**INVITATION TO BID 13-07
2013 Neighborhood Street Resurfacing**

Addendum 1

Date Issued: August 30, 2013

DETAIL 03410-09 COBB COUNTY WATER SYSTEM MANHOLE ADJUSTMENT IN PAVEMENT

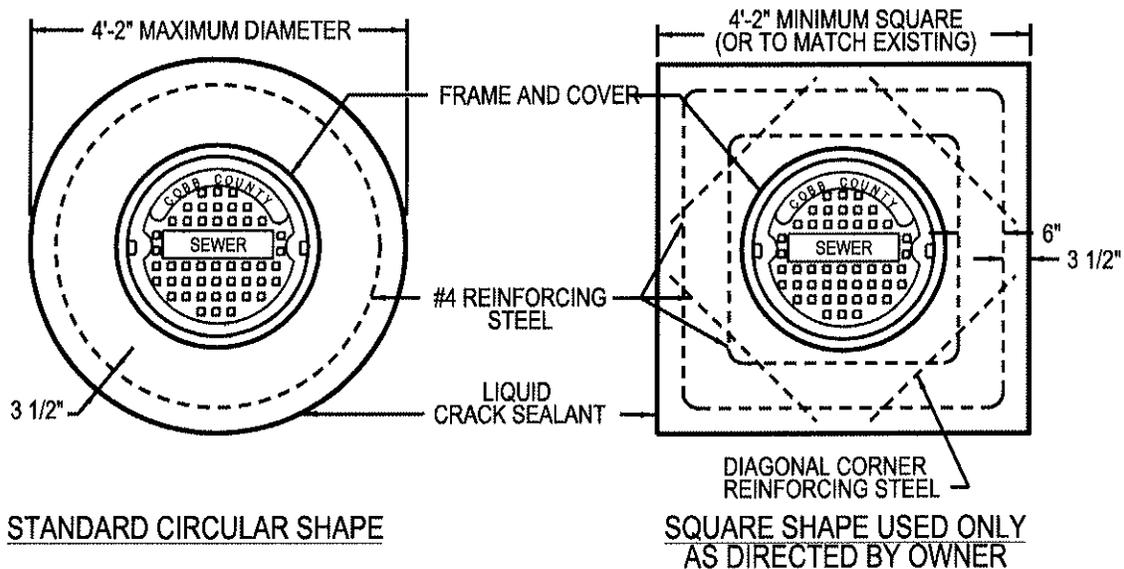
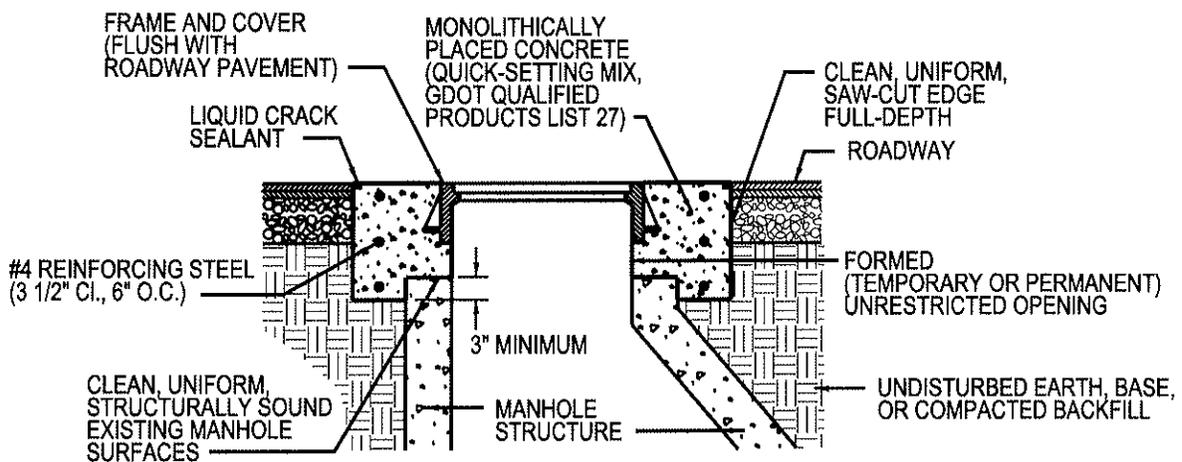
9. Is there a diagram showing exactly how the City of Dunwoody wants the Concrete Collars to be installed on the manholes? **See the attached detail.**

IF REPLACEMENT OF THE FRAME & COVER IS NECESSARY, ACCEPTABLE PRODUCTS ARE EAST JORDAN IRON WORKS V-1480-1, V-2480, V-2480-1, OR U.S. FOUNDRY 360E OR 360E/WT AS REQUIRED BY FIELD CONDITIONS OR DIRECTED BY OWNER.
